TITLE	PARTIAL MEZZANINE/LOW ROOF FRAMING PLAN - AREA B (SEQ-1)		
MADE BY	DATE	CONTRACTOR	JOB No.
PDS	11/30/2020		20028
CHKD BY	DATE	ARCHITECT	ENGINEER
JSY	11/30/2020		
			SHEET NO.
			1E1
			REV.
			A

**PARTIAL MEZZANINE/LOW ROOF FRAMING PLAN @ AREA-B (SEQ-1)**  
 (REF: S2.2 & 1/A1.3)  
 [TOP OF STEEL ELEVATION 114'-0 1/2" U.N.O.]

TITLE		ROOF SECTIONS @ AREA B		
MADE BY	DATE	CONTRACTOR	JOB No.	
PDS	11/30/2020		20028	
CHKD BY	DATE	ARCHITECT	ENGINEER	SHEET NO.
JSY	11/30/2020			1E14
				REV.
				A

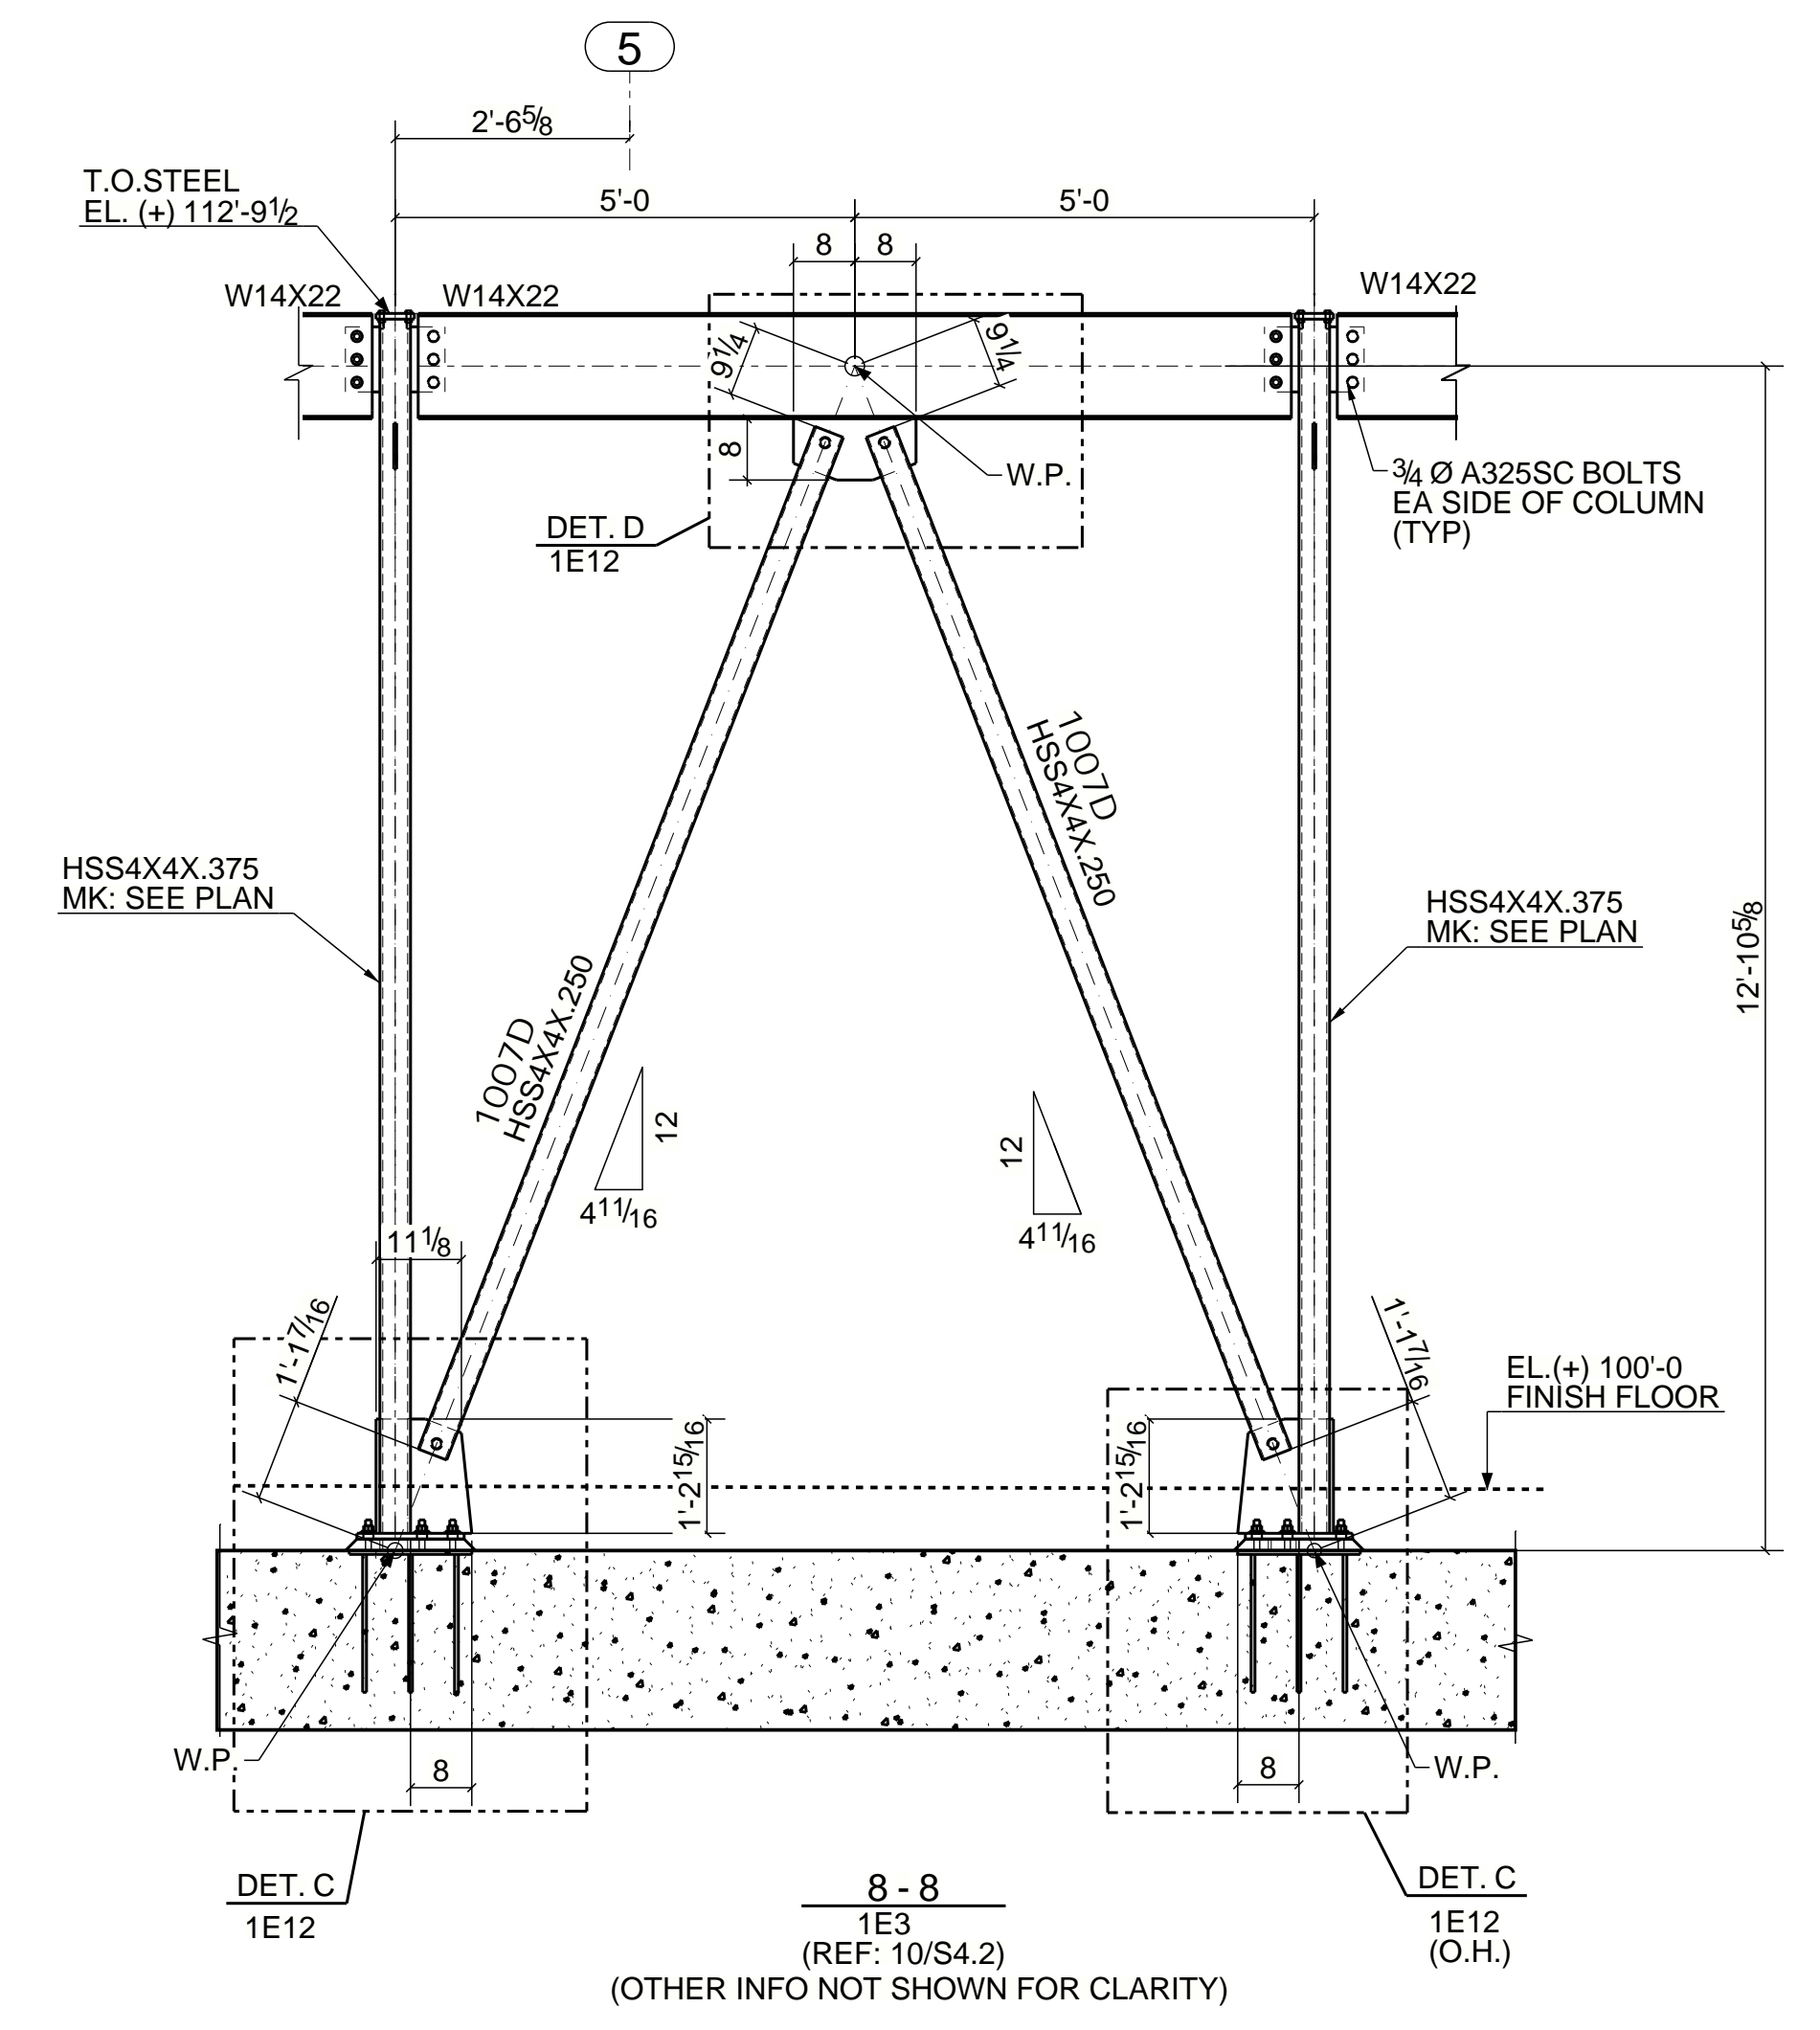
NOTE #1:- WE HAVE NOT CONSIDERED STIFFENER PLATE WHERE THERE IS NO CONNECTION ABOVE BEAM. PLEASE VERIFY/SUGGEST.

NOTE #2:- PLEASE VERIFY/CO-ORDINATE THE JOIST PANEL POINT DIMENSION WITH JOIST SUPPLIER.

NOTE #3:- WE HAVE FOLLOWED ANGLE SIZE L2 1/2X2 1/2X1/4 IN PLACE OF L2 1/2X2 1/4X1/4 AS SHOWN IN DETAIL 1/S5.2, BECAUSE L2 1/2X2 1/4X1/4 IS NOT AVAILABLE IN AISC. PLEASE REVIEW/CONFIRM.
